TO: DEVELOPMENT REVIEW BOARD **DATE:** 2/17/2000
FROM: COMMUNITY DEVELOPMENT
SUBJECT: CASE 10-DR-00

REQUEST: Approve Renovation for an Existing Convenience Store
PROJECT NAME: Circle K Store #195
LOCATION: 3640 North Miller Road

STAFF RECOMMENDATION: APPROVE subject to the attached stipulations.

① CROSS SECTION PROFILE OF STOREFRONT CANOPY

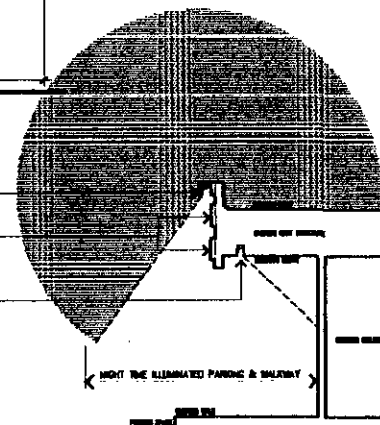
Recessed can lighting is proposed under the storefront canopy. Cove lighting containing fluorescent tube lamps is proposed along the top of the fascia directed downward. To help prevent this cove lighting from lighting the entire fascia, it has been stipulated to conform to a lighting detail showing the following:

- Low intensity/low output fluorescent lamps
- A series of screening louvers below the fluorescent lamps
- A reflector behind the lamps to project lighting away from the fascia

1. *Cove lighting along the top of the fascia shall be directed downward and conform to a lighting detail showing the following:*
 - *Low intensity/low output fluorescent lamps*

- *A series of screening louvers below the fluorescent lamps*
 - *A reflector behind the lamps to project lighting away from the fascia*
 - **A PHOTOMETRIC ANALYSIS SHOWING THAT THE NEW LIGHTING LEVELS ARE LOWER THAN THE EXISTING LIGHTING LEVELS**

EAST ELEVATION W/ TILED WAINSCOT AND FASCIA
SHEET 10-DR-00

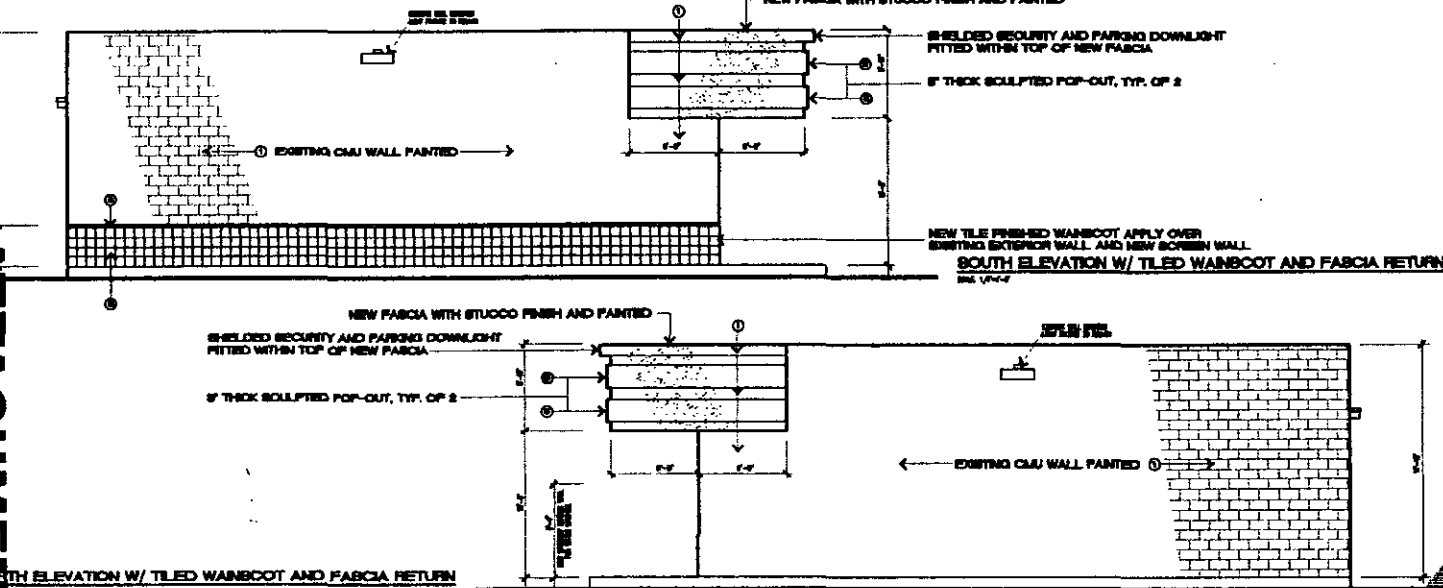
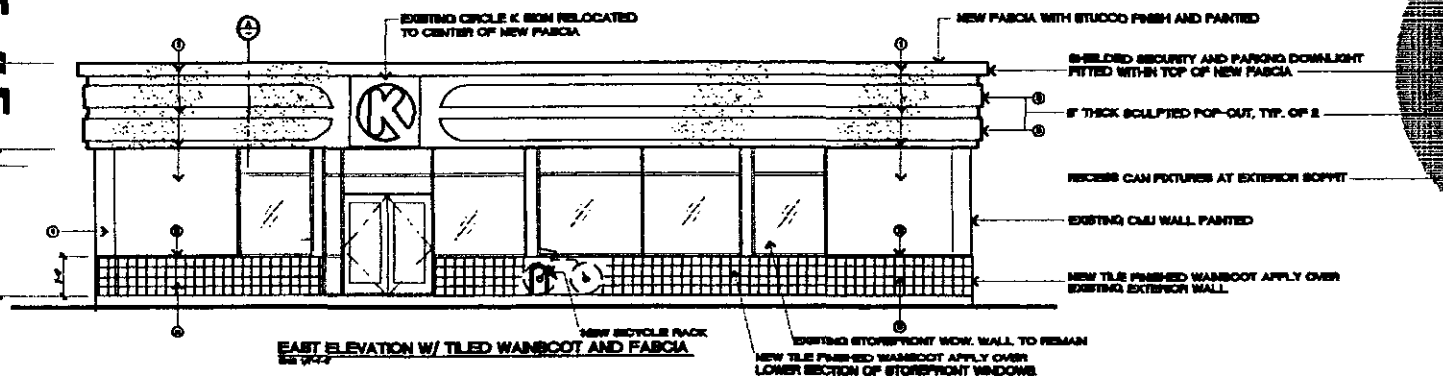
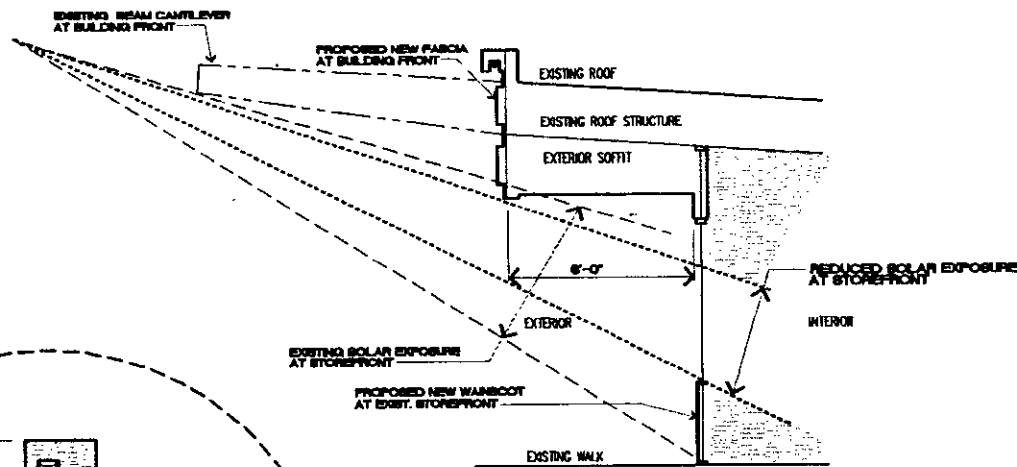
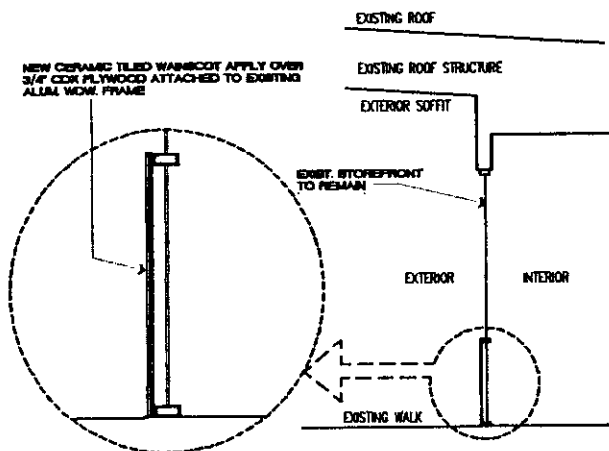
1. *The break in the fascia pop-out feature for the sign shall be located over the door to highlight the entrance of the building.*
2. *The applicant shall provide a minimum 5.5 foot tall perforated metal screen (colored to match the building) to screen any ice cabinets located in the front of the store*

GROUND MOUNTED METAL SCREEN SET IN FRONT OF OUTDOOR EQUIPMENT

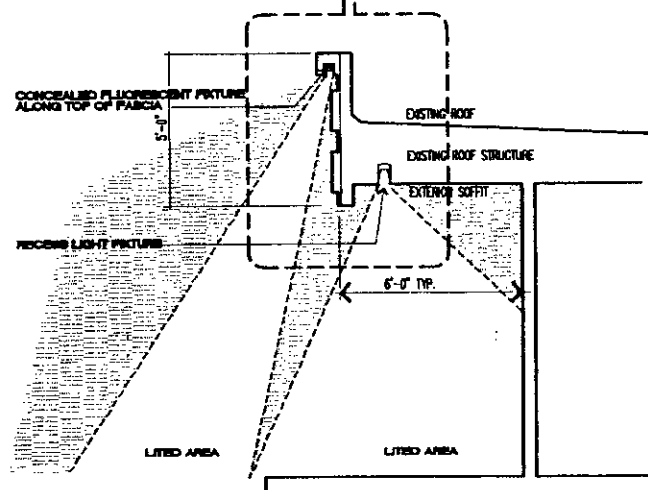
DISCUSSION: The applicant is requesting approval for an exterior renovation for the existing convenience store located at 3640 N. Miller Road. The existing building is a block building with a cantilevered awning element and floor-to-ceiling windows at the front. The proposal includes the replacement of the cantilevered awning with a new 5'-10" tall stucco roof fascia containing two 1.5 foot-wide beige-colored stucco bands popping out 3 inches from the fascia. The new fascia wraps the front (east) elevation, and portions of the north and south elevations. The break in the fascia pop-out feature for the sign is located over the door to highlight the entrance of the building. The proposal also includes replacing the lower storefront glass with a beige ceramic tile wainscot, and wrapping the wainscot on the front (east) and south elevations. A red tile accent is located on top of the beige wainscot. Further, the applicant proposes to repaint the building an "egret white" color and provide a 5.5 foot tall perforated metal screen (colored to match the building) to help screen the ice cabinet located in the front of the store.
